BOARD OF VARIANCE REFERRAL LETTER

DATE: October 20, 2015	DEADLINE: November 10, 2015 for the December 03, 2015 hearing	<i>This is <u>not</u> an application. Please take letter to Board of Variance. (Clerk's office - Ground Floor)</i>
NAME OF APPLICANT: Ying Muoi HO		
ADDRESS OF APPLICANT: 8210 Burnlake Drive		
TELEPHONE: 778.929.8918		
PROJECT		
DESCRIPTION: Addition and interior alteration to main & upper floor of an existing family dwelling		
ADDRESS: 8210 Burnlake Drive		
LEGAL:	LOT: 202	DL: 40
		PLAN: 48688

Zone/Section(s) R1 [101.8]
of the Burnaby Zoning Bylaw No. 4742

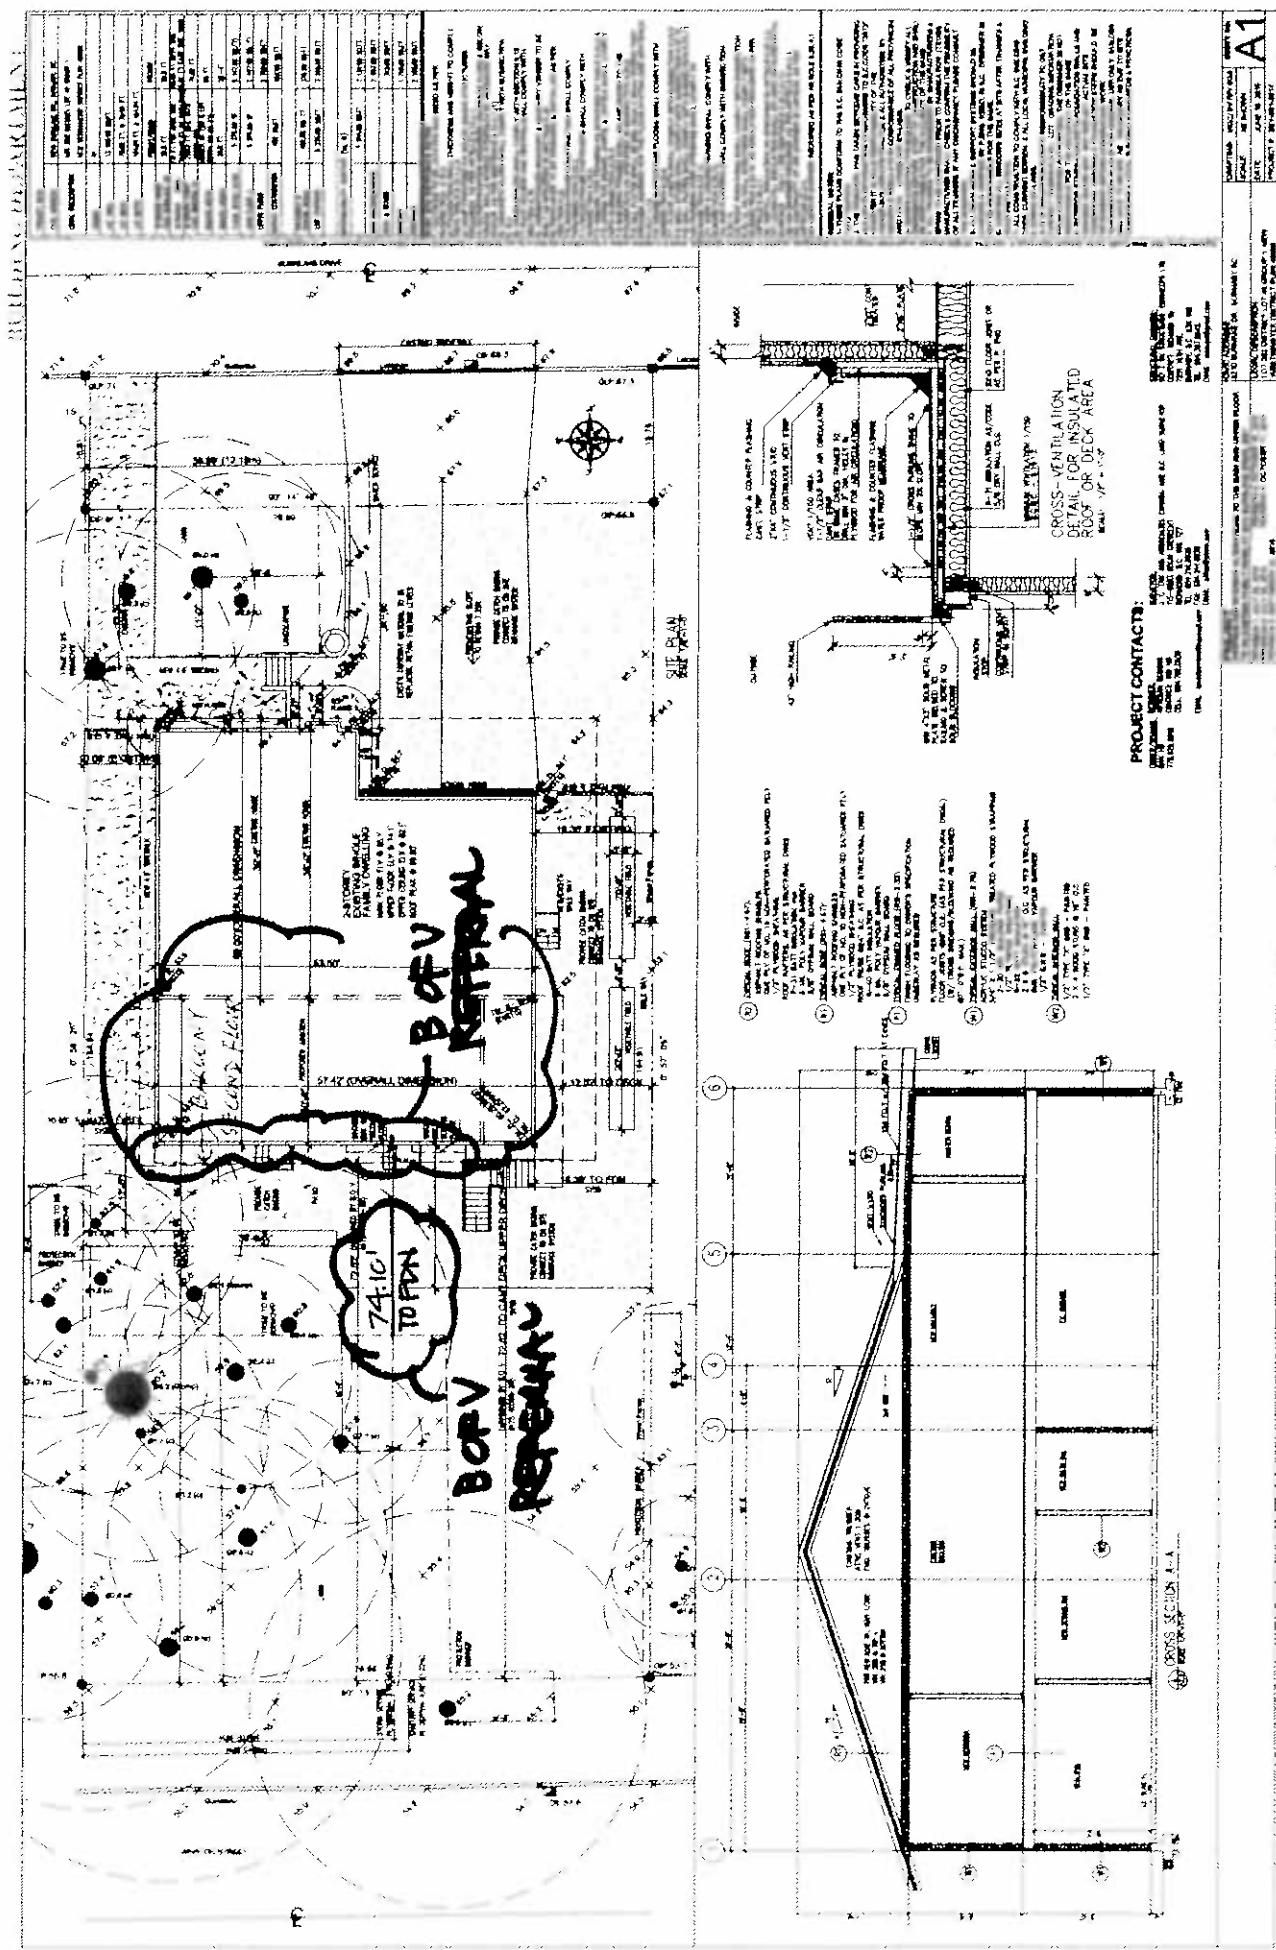
The applicant is proposing to build an addition to an existing single family dwelling. The following relaxation is requested:

- 1) The front yard setback from the Winston Street property line will be 74.10 feet to the foundation where a minimum front yard setback of 85.24 feet is required based on front yard averaging. A balcony will project 1.5 feet beyond the foundation and two window bays will project 1.0 feet beyond the foundation.
